HISTORIC PRESERVATION COMMISSION

ALTERATION TO A HISTORIC PROPERTY STAFF REPORT

Site: 359-365 Broadway
Case: HPC 2017.001

Date of Application: January 24, 2017
Legal Notice: *Alter egress; add decks; alter windows of ell & add AC*
Staff Recommendation: *Conditional Certificate of Appropriateness*
Date of Public Hearing: February 21, 2017

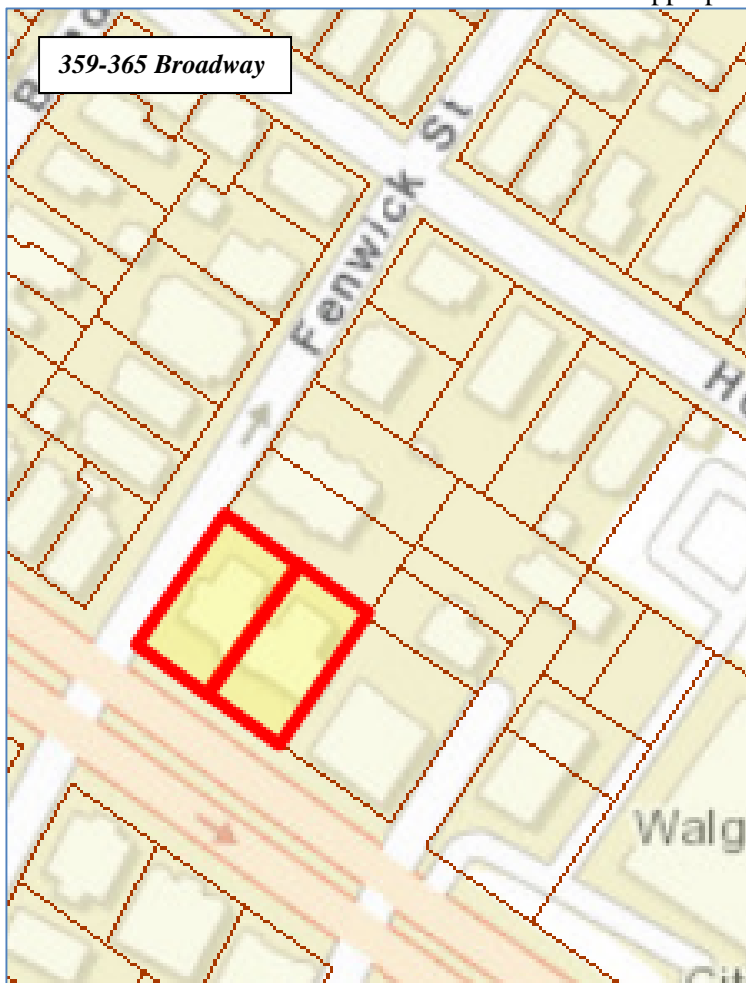
The new roof decks are visible from the public rights of way and are located on the rear of the building. However the rear of the building is extremely visible as are the decks. Metal railings might be less visible but any furniture or plants would stand out. The existing railing system is modern in effect and has no pretensions of being original to the design of the building.

1. All appropriate building permits shall be obtained prior to the start of any work.
2. Alter egress to include enlarged landings and decks.
3. The railings shall be of a generic style indicative of new construction and composed of wood.

4. The top of the porch railings shall meet building code.
5. The replacement balusters shall be simple square balusters.
6. The replacement posts shall be finished with a simple pyramidal cap.
